INFO SERVICE BULLETIN No. 08

Information regarding replacements of Wheel Brake Assembly

Applies to all Sinus/Virus aircraft up to SN 240.

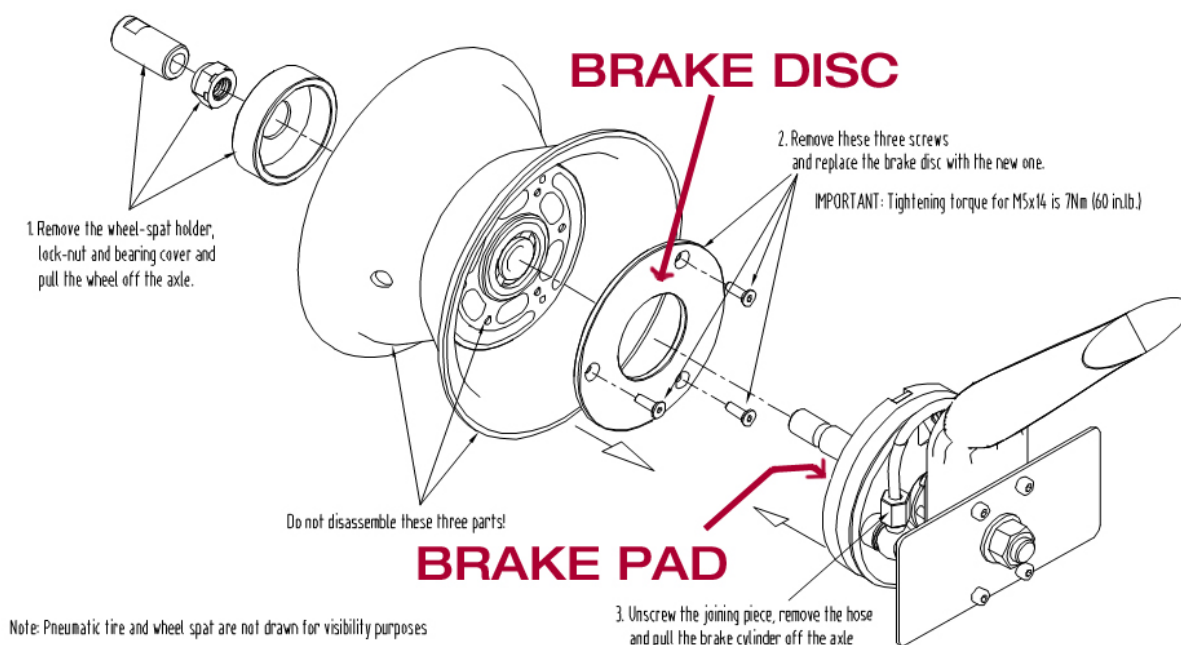
Upon replacement of Wheel Brake Assembly, it is necessary to replace both brake pads and brake discs. The reason for this is that new brake pads are not compatible with old brake discs and vice versa. When ordering individual parts from Pipistrel d.o.o. Ajdovscina, make sure you order according to the below part numbers of the individual components of the wheel brake assembly. This is to ensure problem-free operation.

WARNING! Should the incorrect combination of brake discs and pads be used, braking action may be deteriorated greatly.

7267 Wheel brake disc

7274 Wheel brake pad
